FOR DAC

JOB TITLE		
Christ Church Hampstead		
DRAWING TITLE		
West Elevation Existing Condition		
JOB No.	DWG No.	REV
537A	SU06	-
DRAWN BY	SCALE (AT A1)	DATE
JMc	1:100 (1:200@A3)	Dec14

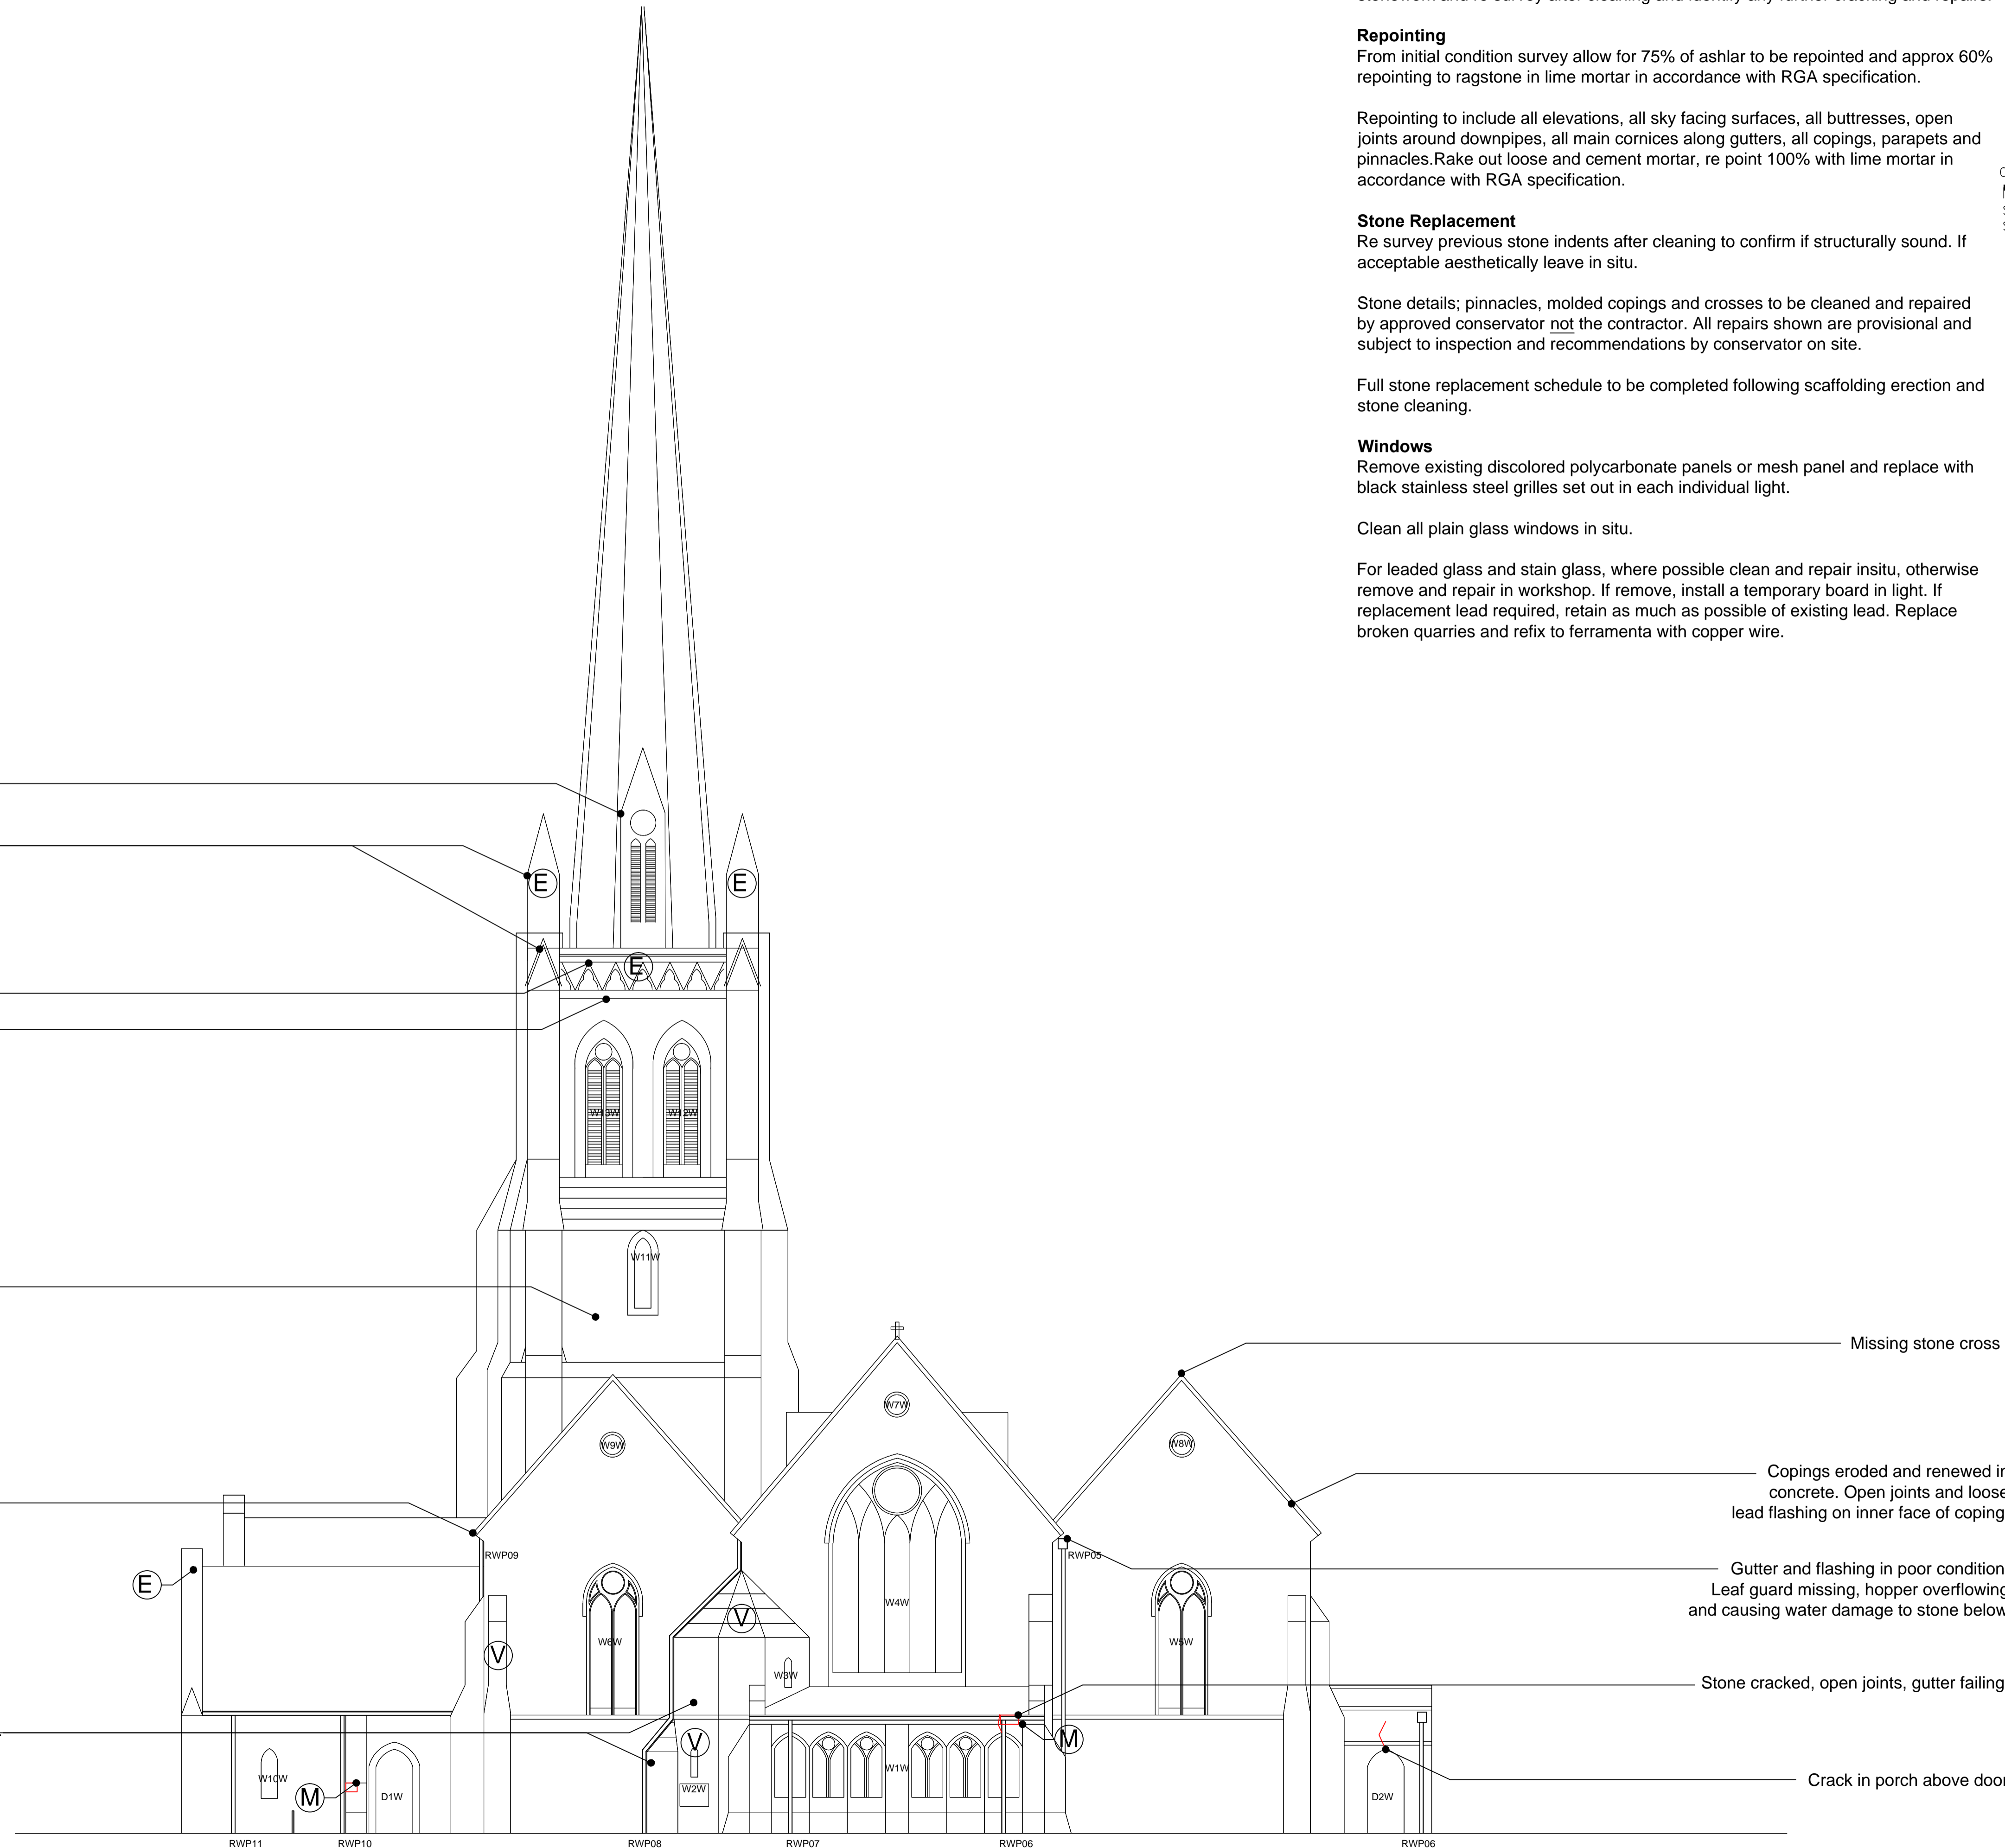
Staining to stonework on tower above window

Parapets, copings and pinnacles eroded, missing pieces of stone and at risk of falling

Open joints to parapet. Stone replacement to confirmed on closer inspection.

Slate tiles to drain water from perimeter of parapet are cracked and loose. Outlets from base of parapet are in asphalt and in poor condition.

Eroded/Partial missing stone to ragstone on tower buttress.

Leaf guard missing, hopper overflowing and causing water damage to stone below.

Stone below on stair tower is water damaged and discoloured. Washed out mortar joints and mos/algae build up.

Missing stone cross

Copings eroded and renewed in concrete. Open joints and loose lead flashing on inner face of coping.

Gutter and flashing in poor condition. Leaf guard missing, hopper overflowing and causing water damage to stone below

Stone cracked, open joints, gutter failing.

Crack in porch above door

Due to limited roof access, inspection undertaken from ground level and tower parapet. Carry out a closer roof inspection, by scaffolding, to ascertain any repairs required to slates, battens, underlay, gutters and flashings. Replace slates and lead flashing to all areas of roof as RGA condition survey and specification and LSA recommendations.

All areas to be DOFF cleaned early in contract. Conservation Architect to explore stonework and re survey after cleaning and identify any further cracking and repairs.

From initial condition survey allow for 75% of ashlar to be repointed and approx 60% repointing to ragstone in lime mortar in accordance with RGA specification.

Repointing to include all elevations, all sky facing surfaces, all buttresses, open joints around downpipes, all main cornices along gutters, all copings, parapets and pinnacles. Rake out loose and cement mortar, re point 100% with lime mortar in accordance with RGA specification.

Re survey previous stone indents after cleaning to confirm if structurally sound. If acceptable aesthetically leave in situ.

Stone details; pinnacles, molded copings and crosses to be cleaned and repaired by approved conservator not the contractor. All repairs shown are provisional and subject to inspection and recommendations by conservator on site.

Remove existing discoloured polycarbonate panels or mesh panel and replace with black stainless steel grilles set out in each individual light.

For leaded glass and stain glass, where possible clean and repair insitu, otherwise remove and repair in workshop. If remove, install a temporary board in light. If replacement lead required, retain as much as possible of existing lead. Replace broken quarries and refix to ferramenta with copper wire.
